CENPD-283-NP-RAI
(NRC TAC No. M86126)

**BWR ECCS Evaluation
Model: Boiling Water
Reactor ECCS
Evaluation Model:
Response to Request for
Additional Information
on Code Sensitivity for
SVEA-96 Fuel**

June 1995

Figure A9-7 Core Void Fraction at 20 Seconds versus Core Elevation

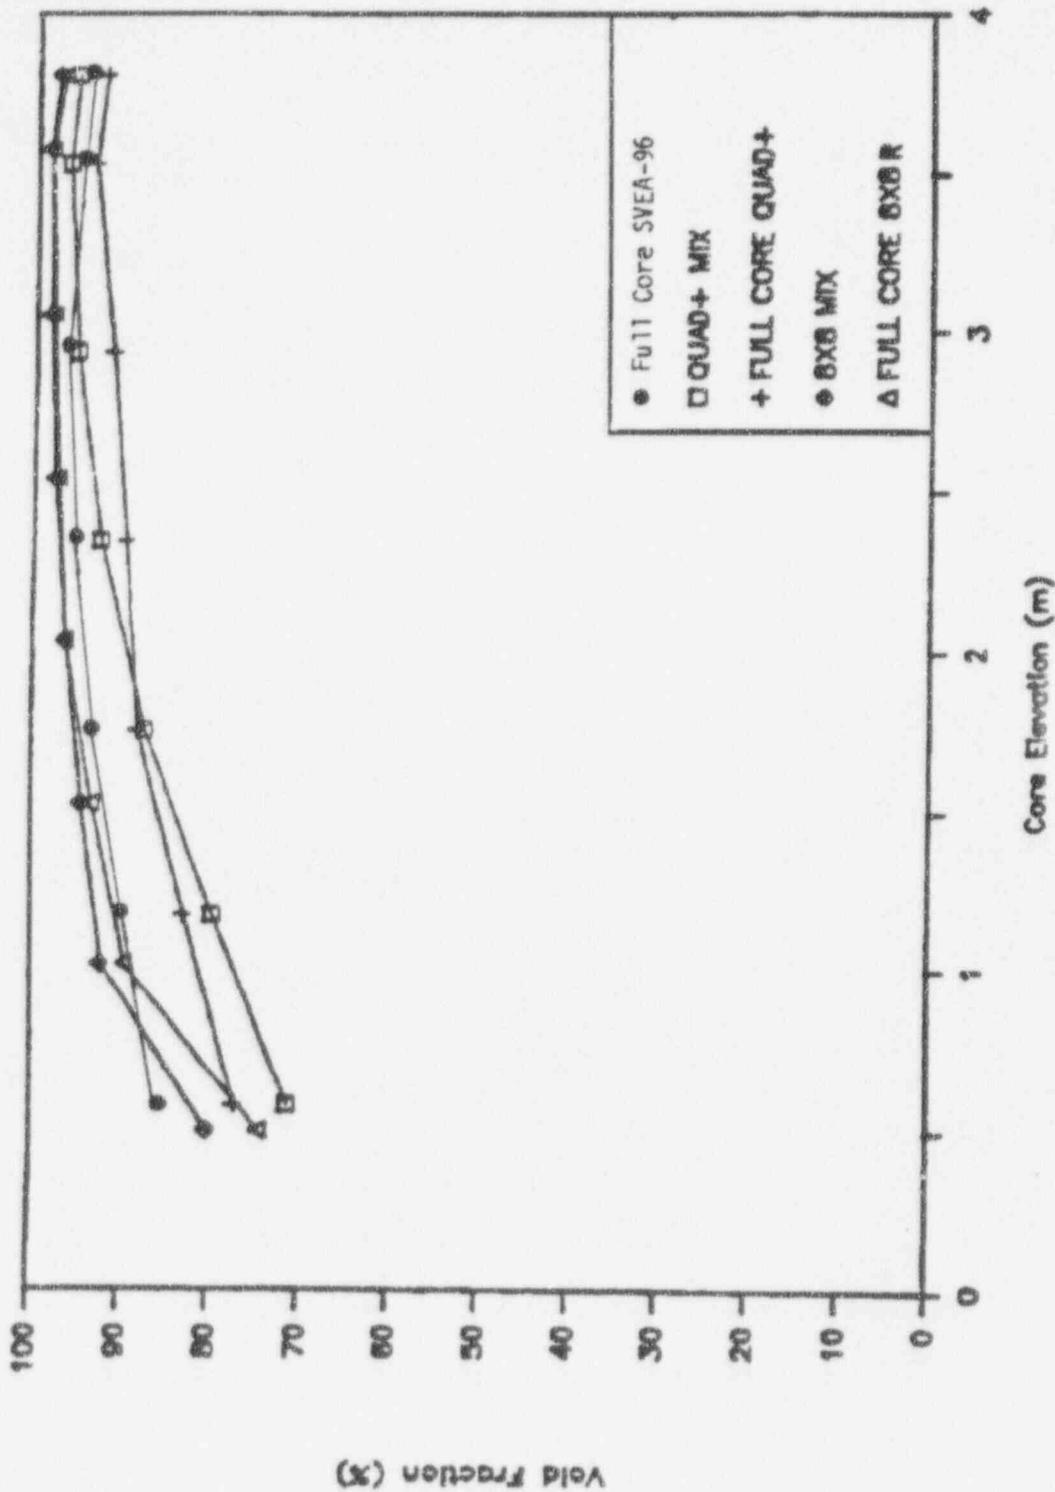
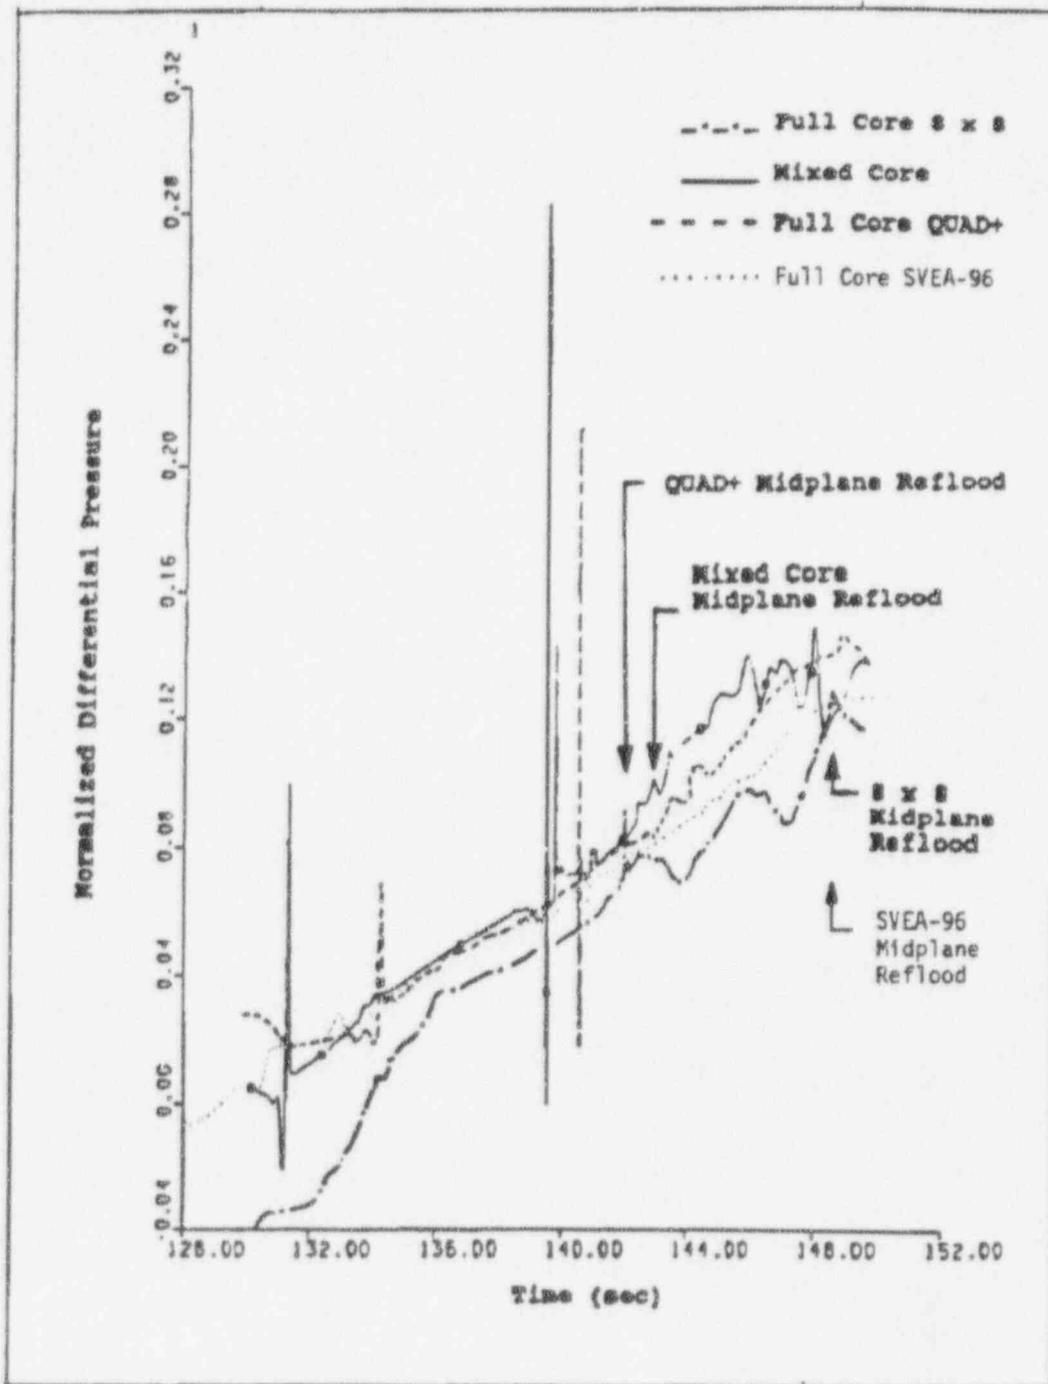
Mixed core effects should be investigated further to support ABB/CE's position regarding the transition cores by presenting mixed core analysis results with transition from QUAD+/SVEA64 fuel to SVEA-96 fuel. The watercross for each fuel design should be explicitly modeled in the nodalization. Provide plots from core void fraction, pressure, flow, and flow velocities.

A sensitivity study for transition cores was reported in response to Question 5 of RPB-90-94-P-A (Reference A5). To further demonstrate the discussion presented and conclusions drawn in the response to Question 5 of RPB-90-94-P-A are valid in general, the results for a full core of SVEA-96 were compared to the previous system responses in Section 8 of Reference A1. Additional comparative results are shown in Figures A9-1 through A9-8 which correspond to Figures 5-1 through 5-8 on pages 18 through 25 of the Addendum to RPB 90-94-P-A. There are insignificant differences between the system responses of the four cores presented.

As discussed in Response 5 of RPB-90-94-P-A small differences in the responses are attributed to differences in fuel component designs. As noted in Response A1 of this document, the SVEA-96 core used as an example was not specifically design to be hydraulically comparable with the previous example cores (i.e., QUAD+ and 8x8). Hence, in some instances in Figures A9-1 through A9-8, the SVEA-96 results deviated slightly more than those observed for the other cores configurations. However, the overall system responses are very similar.

The results presented here further substantiate the general conclusion that the core average system response is relatively independent of local differences in fuel assembly design.
